Re: CA Student Living LLC Application for Site Plan Review and Approval to Develop  
Multi-Family Housing at 1 Ridgewood Road, Ithaca (the "Project")

- Exhibit A:** Revised Site Plan Sheet G104
- Exhibit B:** Revised Site Plan Sheet L005
- Exhibit C:** Revised Site Plan Sheet L201
- Exhibit D:** Revised Site Plan Sheet L301
- Exhibit E:** Revised Full EAF with Informational Details Attached
- Exhibit F:** Phase 1A/1B Cultural Resource Survey
- Exhibit G:** Geotechnical Subsurface Investigation Report

LAYOUT PLAN

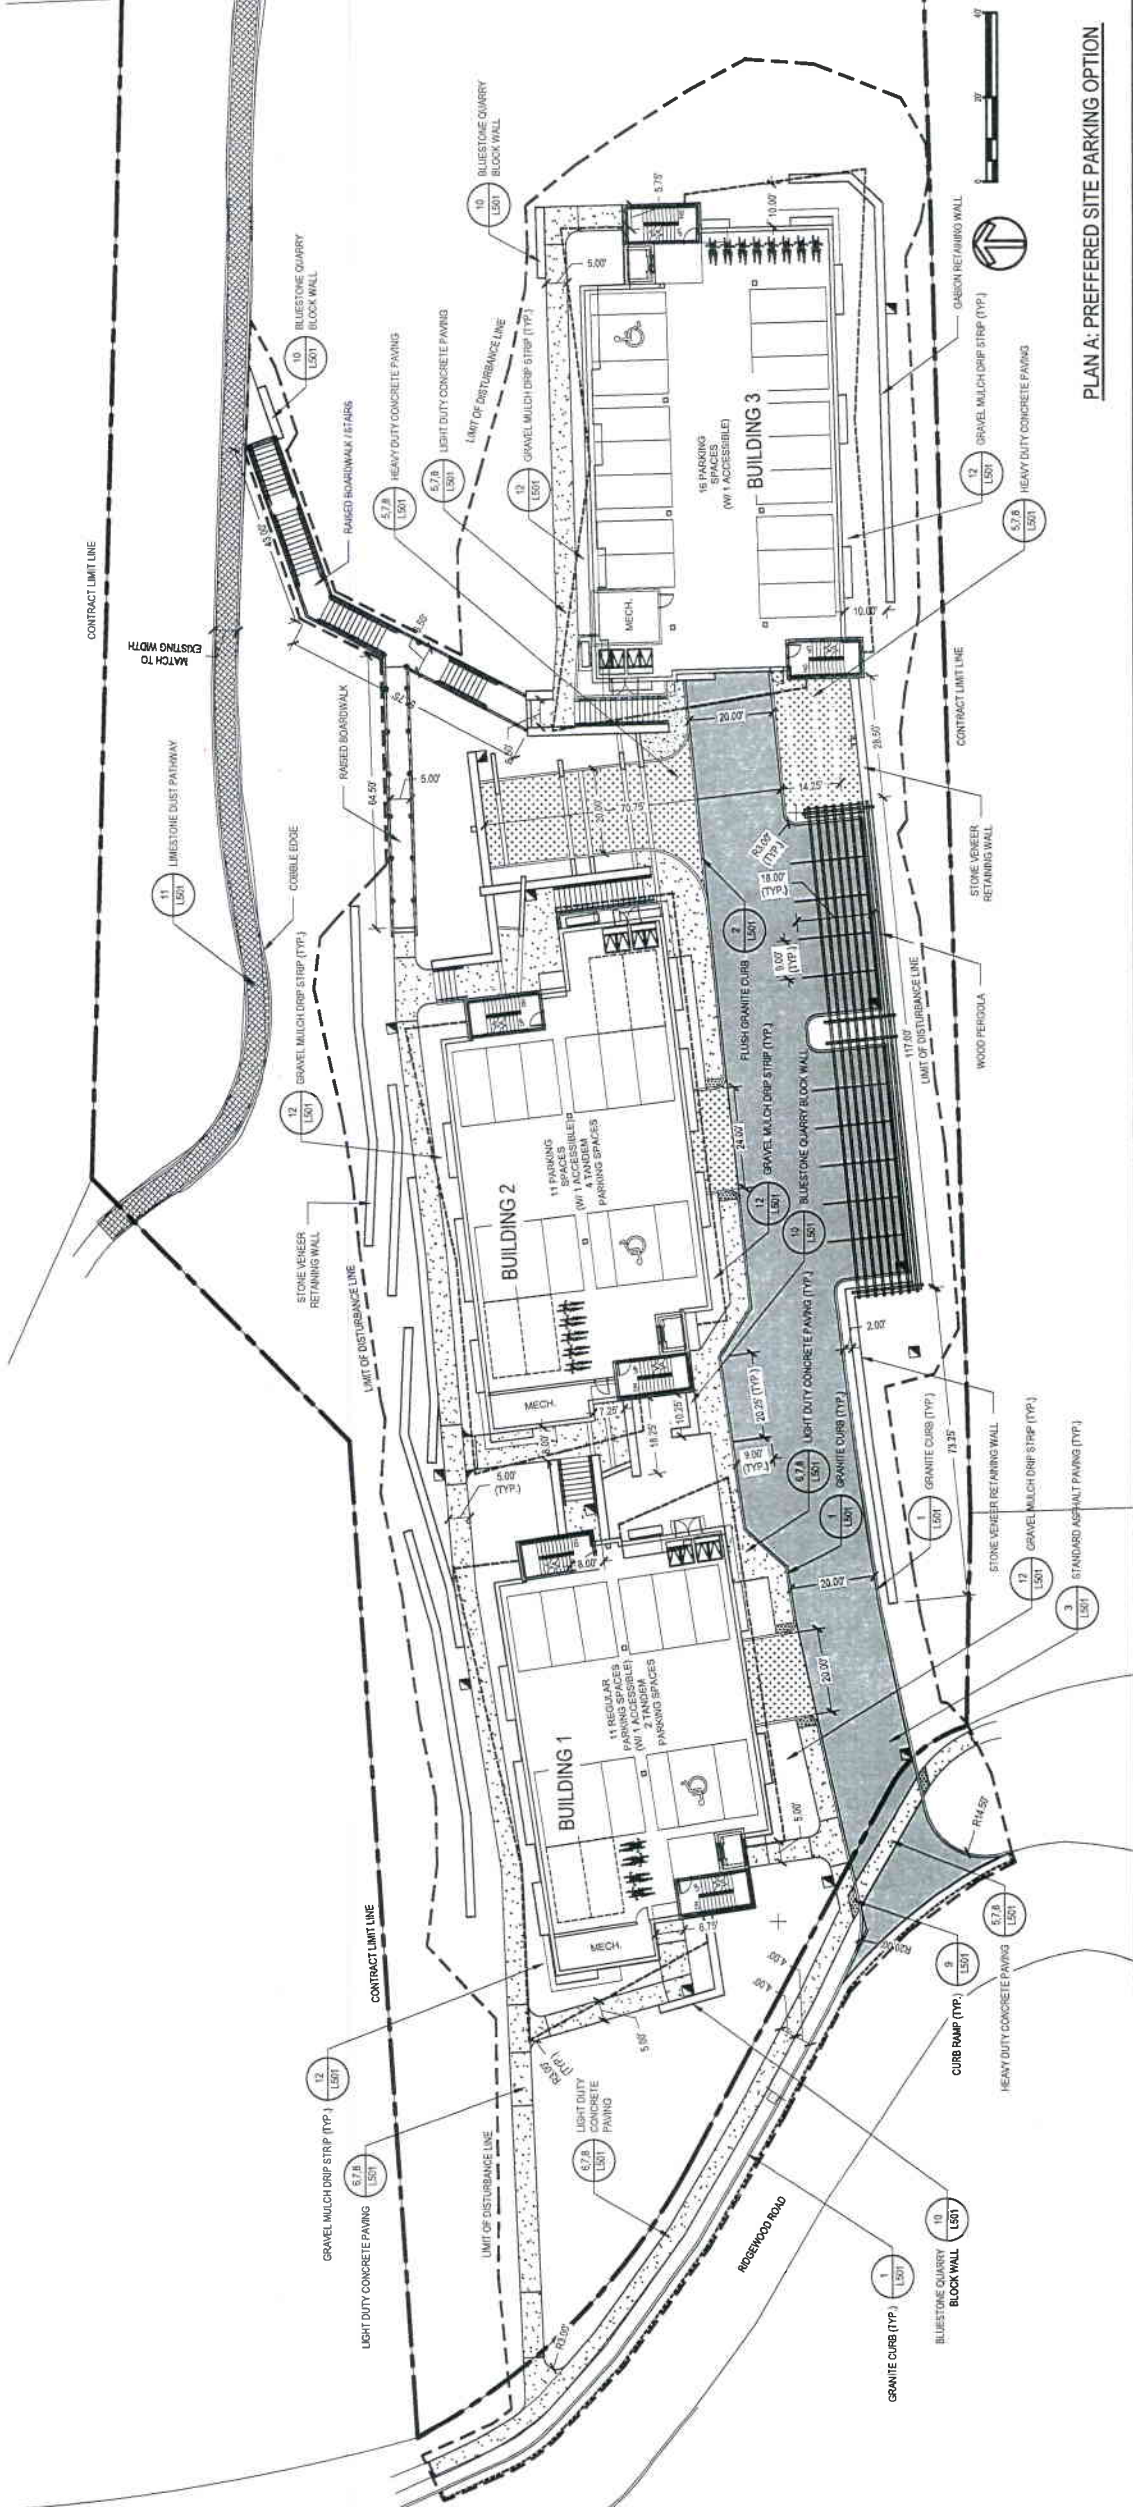
As requested, provided as **Exhibits C and D** are two revised drawings, the Layout Plan (L201) and the Grading Plan (L301). Each has been revised to more prominently show the area of disturbance. Additionally, the property setback line has been removed from L201 and the convention for the property line on these drawings has been revised per the City's feedback.
